# Product Support Bulletin 2009-003

## Maintenance of Way ~ Work Equipment Bulletin

**SUBJECT:** Up/Down Cylinder Bushing Added to Workhead Frames – 22133746

**MACHINE MODEL(S):** CX Hammer  
C-CX Hammer Conversions

Figure 1

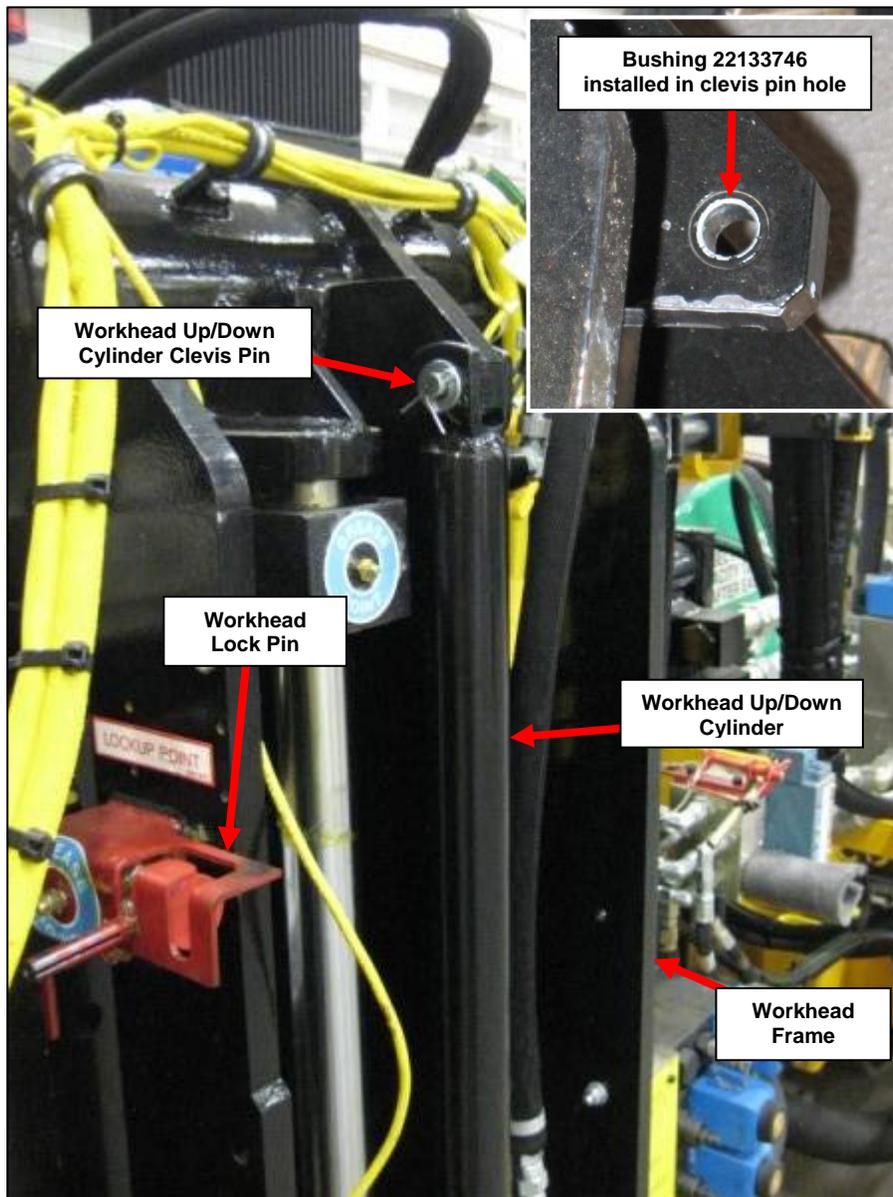
**SUMMARY:** The 22133746 Workhead Frame Bushing is installed in the upper clevis pin hole for the Hammer Up/Down Cylinder to prevent the pin from wearing out the base material of Workhead Frame.

**ACTION:** All machines with serial numbers 410867 and higher have the bushing installed. If bushing replacement is necessary, the bushing may be pressed out and a new bushing pressed into place. See Figure 1 on Page 2. The following replacement Workhead Frames are also affected by this change:

Due to the fine tolerance involved in boring the bushing hole, field installation of the bushing into a worn Workhead Frame or one which does not have the correct bore size for the bushing is not recommended.
